**Report: TAB Report**  
**Function: Test, Adjust, & Balance**  
**Date: 09/04/2025**  
**Completed By: National TAB**

**PROJECT**  
**08-25-25 CAVA DANBURY, CT**

Project: 08-25-25 CAVA DANBURY, CT

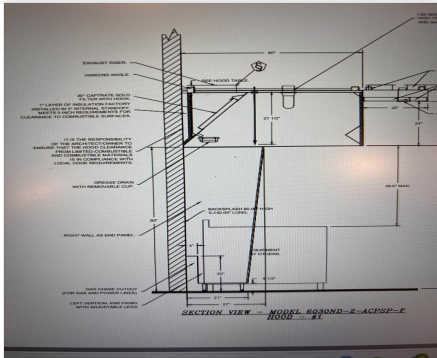
**Issue Name :** HD1: Gap Next to Wall  
**Description :** Small gap between hood and well. Recommend filling.  
**Created By :** National TAB                      **Assigned To :** National TAB - Dan Hertenstein  
**Status :** Open  
**Priority :** Low                                      **Asset Tag :**  
**Originated Date :** 08/25/2025 - Ryan Smith - National TAB

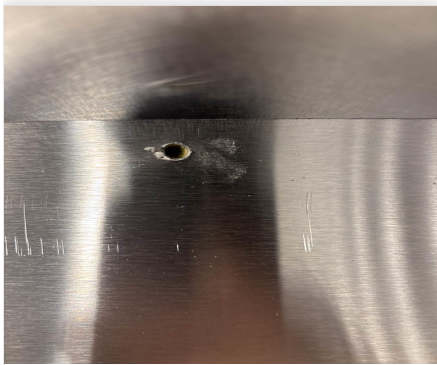
**Issue Name :** HD1: Not Caulked Along Wall  
**Description :** Hood not caulked where it meets wall. Recommend caulking.  
**Created By :** National TAB                      **Assigned To :** National TAB - Dan Hertenstein  
**Status :** Open  
**Priority :** Medium                                      **Asset Tag :**  
**Originated Date :** 08/25/2025 - Ryan Smith - National TAB

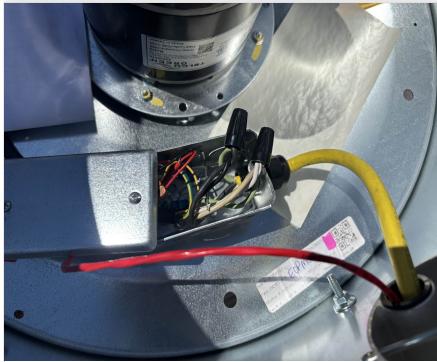
**Issue Name :** KEF1: Electrical Boxes Left Open  
**Description :** Electrical boxes are open, potentially exposing wiring to elements. Recommend closing.  
**Created By :** National TAB                      **Assigned To :** National TAB - Dan Hertenstein  
**Status :** Open  
**Priority :** Low                                              **Asset Tag :**  
**Originated Date :** 08/25/2025 - Ryan Smith - National TAB

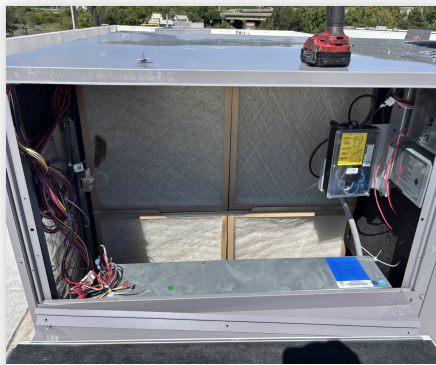
**Issue Name :** RTU1, RTU2: Construction Filters Still Installed  
**Description :** Construction filters still installed in both RTUs. Recommend replacing with MERV8 filters.  
**Created By :** National TAB                      **Assigned To :** National TAB - Dan Hertenstein  
**Status :** Open  
**Priority :** Medium                                      **Asset Tag :**  
**Originated Date :** 08/25/2025 - Ryan Smith - National TAB

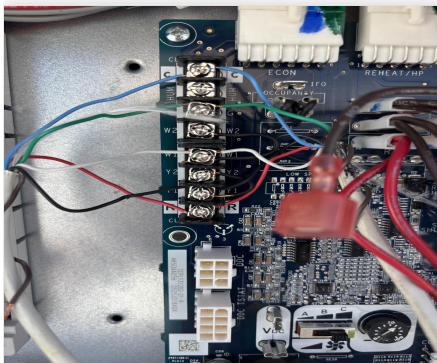
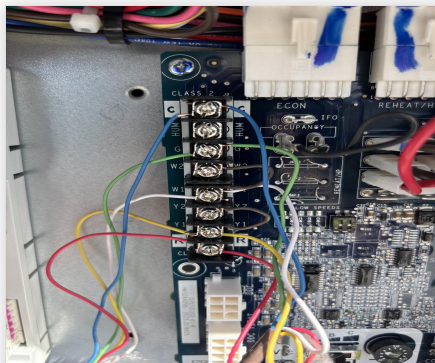
**Issue Name :** RTU1, RTU2: Controller Wiring Incorrect  
**Description :** Controllers in RTUs are wired incorrectly. Y1 is jumped to Y2 and W1 is jumped to W2. Also, thermostats do not send occupancy signal to correct terminal on board, only toggling fan mode instead.  
**Created By :** National TAB                      **Assigned To :** National TAB - Dan Hertenstein  
**Status :** Open  
**Priority :** Low                                      **Asset Tag :**  
**Originated Date :** 08/27/2025 - Ryan Smith - National TAB

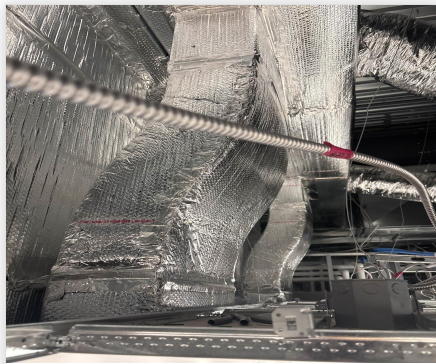
**Issue Name :** RTU1-1: No Dampers in ACPSP  
**Description :** No dampers in ACPSP. Unable to adjust kitchen diffusers.  
**Created By :** National TAB                      **Assigned To :** National TAB - Dan Hertenstein  
**Status :** Open  
**Priority :** High                                      **Asset Tag :**  
**Originated Date :** 08/27/2025 - Ryan Smith - National TAB

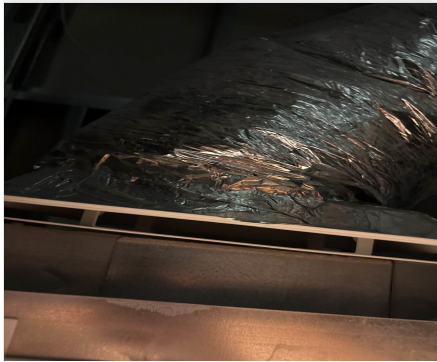
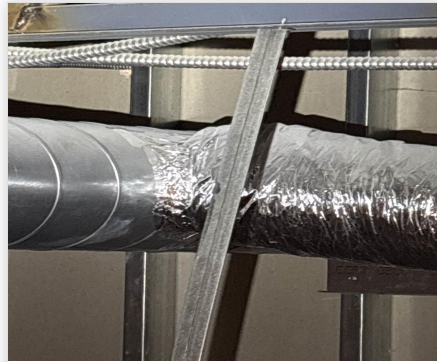
**Issue Name :** RTU2-10,12: No Dampers in Bathroom Supply Diffusers  
**Description :** Bathroom supply diffusers do not have dampers. Unable to adjust.  
**Created By :** National TAB                      **Assigned To :** National TAB - Dan Hertenstein  
**Status :** Open  
**Priority :** Low                                      **Asset Tag :**  
**Originated Date :** 08/27/2025 - Ryan Smith - National TAB

Asset: RTU1

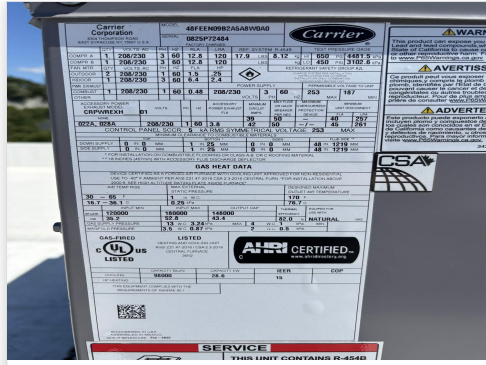
Notes:  
ACPSP does not have dampers. Not able to adjust diffusers. Only balanced total airflow on entire unit.
